CHAFFEY COLLEGE			
TITLE: CYLINDER			
SIZE A	DWG. NO. DRFT21-3	REV A	
SCALE: 2:1	WT: 0.002 (A)	SHEET 1 OF 1

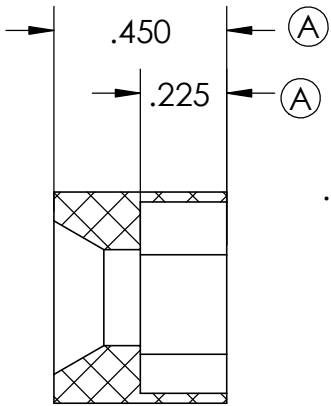
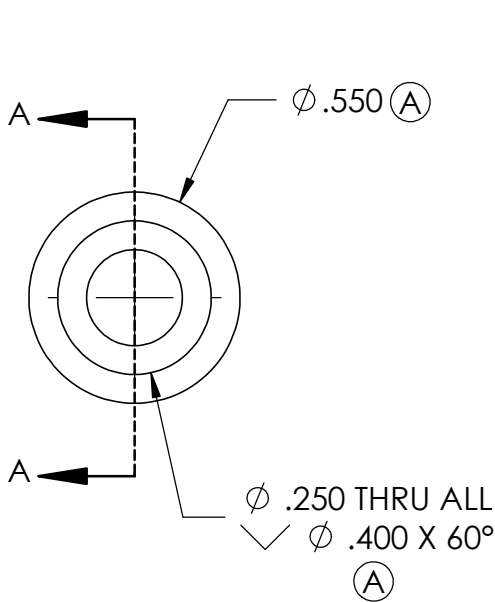
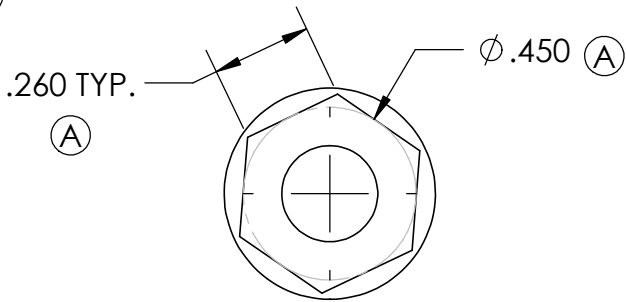
REVISIONS				
ZONE	REV.	DESCRIPTION	DATE	APPROVED
A1, A2, B1, B2	A	CHANGED DIM .750 TO .550, DIM .500 TO .450, DIM .250 TO .225, DIM .173 TO .260, AND DIM .300 TO .450. COUNTERSINK DIM CHANGED TO .400, WAS .500. WEIGHT CHANGED TO .002, WAS .008.	4/28/2023	L.E.
